Response to reviewer #2 Recent six-year atmospheric CO₂ concentration at the summit of Mt. Fuji observed by a battery-powered CO₂ measurement system

Shohei Nomura^a, Hitoshi Mukai^a, Yukio Terao^a, Toshinobu Machida^a and Yukihiko Nojiri^{a,b}

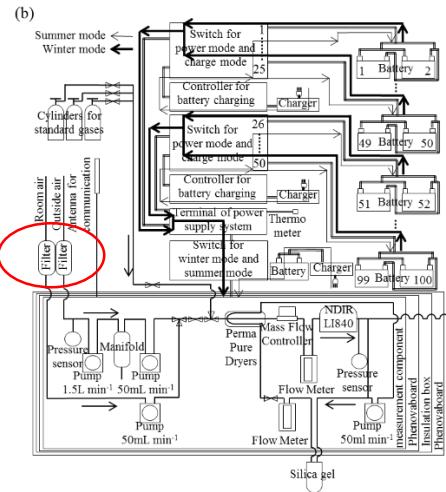
17. Page 4, first paragraph: did you apply any modifications to the measurement setup, in particular to the CO₂ analyzer? E.g. disconnecting the display or reducing the flow through the NDIR to reduce power consumption.

>We did not change the measurement setup in CO₂ analyzer. We connect the PC to CO₂ measurement only summer. We did not connect PC from September to the following June. The system is controlled by the control board and operated automatically.

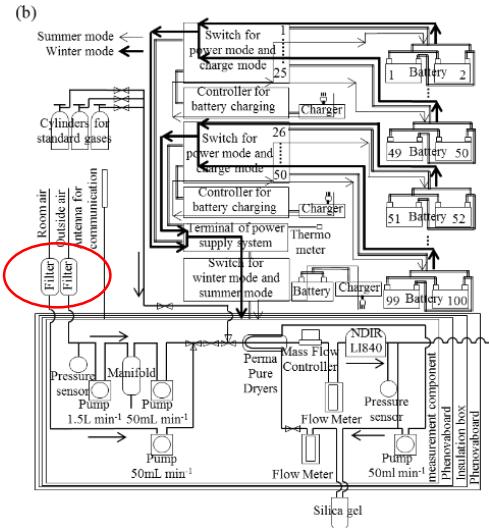
23. Page 5, line 22: did you use an inlet filter when measuring room air?

>We forgot to add an inlet filter of room air in Figure. We added the filter to Figure.

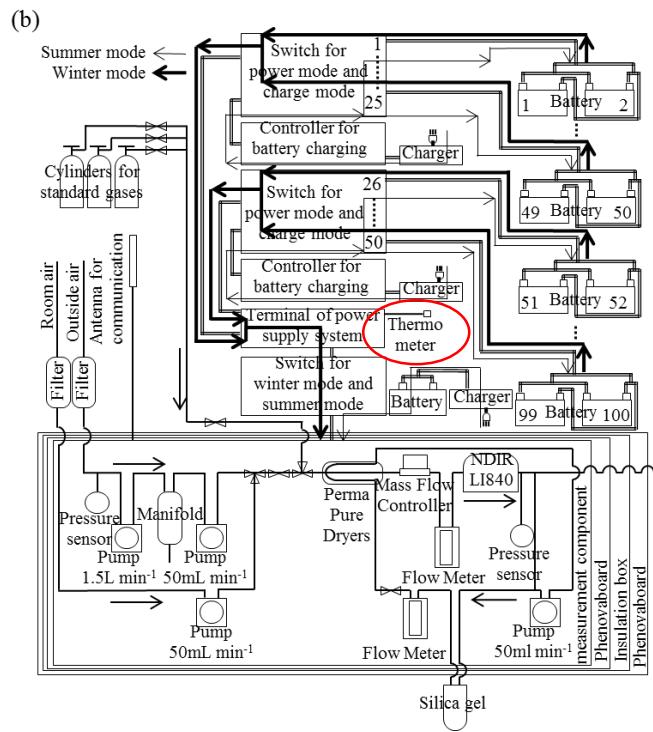
28. Paragraph 2.5 Continuous measurements in summer: Does the continuous system use the same inlet? Did you use the same reference gases? Does the default system operated all year long also only measure for 3.5 hours a day in summer? The summer system has no dryer. Did you test and quantify the CO₂ losses in the Nafion dryer?

>The continuous system used the same inlet as the battery-powered measurement. The continuous system used other working standard gas (But same scale (NIES09) as the battery-powered measurement). The default system measured CO₂ concentration 4 times per day in summer of 2010-2012 to compare bottle sampling measurement. But that, the system worked for 3.5 hours a day.

We checked the measurement of the system without dryer, and found that measurement data matched with our system within 0.3ppm and stability was even better than that. So we only used this system to detect daily variation of CO₂ conc at Mt. Fuji.

As for Nafion effect, because we used the same outside air to dry the sample air, the change of CO₂ conc must be negligibly small.

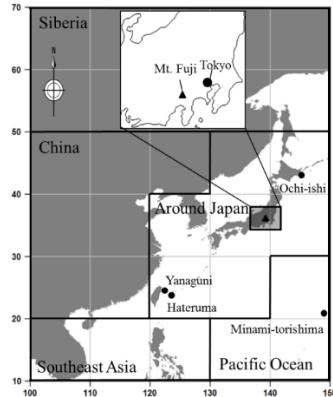
46. Fig. 1: add areas of air mass origin (Fig. 11) to Fig. 1 and delete Fig. 11.

>We merged Fig 11 with 1.

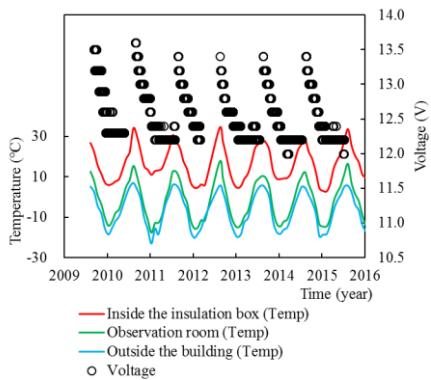
48. Fig. 6, caption: Write “Monthly averages of ambient temperatures outside . . .”

> We deleted the figure of monthly averages of temperatures and created the figure of daily data of temperatures. Also merged temperatures data and voltage data.

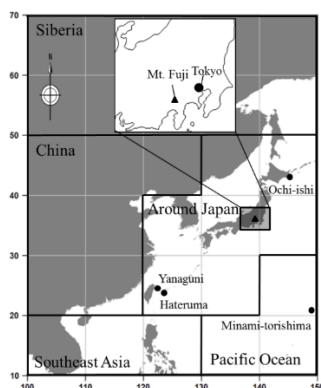
49. Fig. 11: merge with Fig. 1 and delete

>We merged with Fig 11 and 1.
